Before the
Federal Communications Commission
Washington, D.C. 20554

In the matter of)	
)	
ARINC Incorporated)	File Nos. SES-LIC-20030910-01261
)	SES-AMD-20031223-01860
Application for Blanket Authority for Operation)	
of Up to One Thousand Technically Identical)	
Ku-Band Transmit/Receive Airborne Mobile)	
Stations Aboard Aircraft Operating in the)	
United States and Adjacent Waters)	
)	
)	
)	
)	
)

ORDER AND AUTHORIZATION

Adopted: April 5, 2005

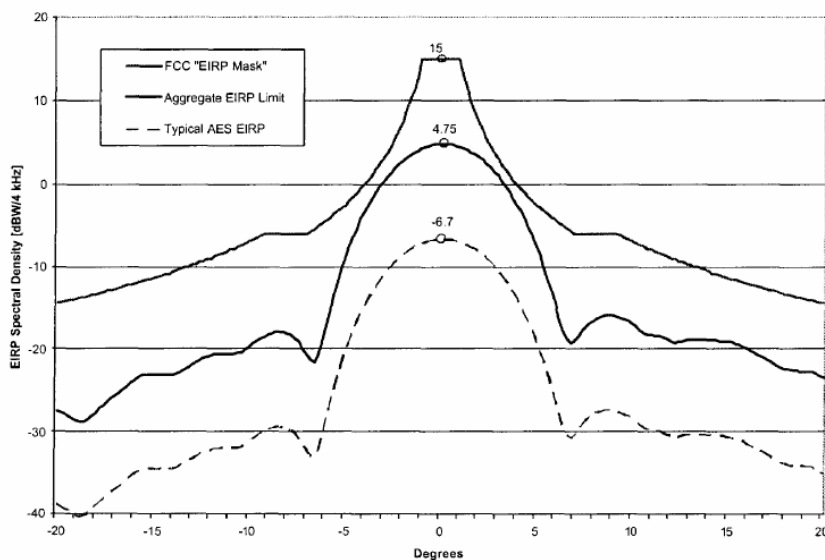
24. The SKYLink System operates with an Aloha/CDMA access protocol that allows multiple simultaneous co-frequency AES transmissions, relying on code differentiation to minimize self-interference. Because SKYLink AES antennas are not large enough to suppress side-lobe gain to the extent necessary for conformance with the limits in Section 25.209(a)(1), ARINC proposes to compensate by limiting AES input power density to levels well below the -14 dBW/4kHz limit for routinely-authorized digital VSAT Earth stations. ARINC determined that if the aggregate input-power spectral density of simultaneously-transmitting co-frequency SKYLink AES terminals does not exceed -24.25 dBW/4kHz, the system’s aggregate uplink off-axis e.i.r.p. density will not exceed a one-dB margin below

the VSAT emission envelope at the worst-case angle, as depicted by the following diagram.³⁴

ARINC asserted in its application that the input power density into a single SKYLink AES terminal would never exceed -24.25 dBW/4kHz and that the aggregate input power density into simultaneously-transmitting SKYLink AES terminals would be kept below that level *almost* all the time, through dynamic network control of AES power, log-ins, and data transmission rates.³⁵ Specifically, ARINC estimated that with 214 SKYLink AES terminals logged in over one transponder the probability of aggregate earth-station on-axis e.i.r.p. density exceeding the -24.25 dBW/4 kHz level at any given point in time would be less than 0.001 percent.³⁶ ARINC asserted that the SKYLink NMS would authorize no more than 214 terminals to be logged in concurrently and therefore maintained that the system's aggregate off-axis e.i.r.p. would be within the VSAT emission envelope at least 99.999 percent of the time.³⁷
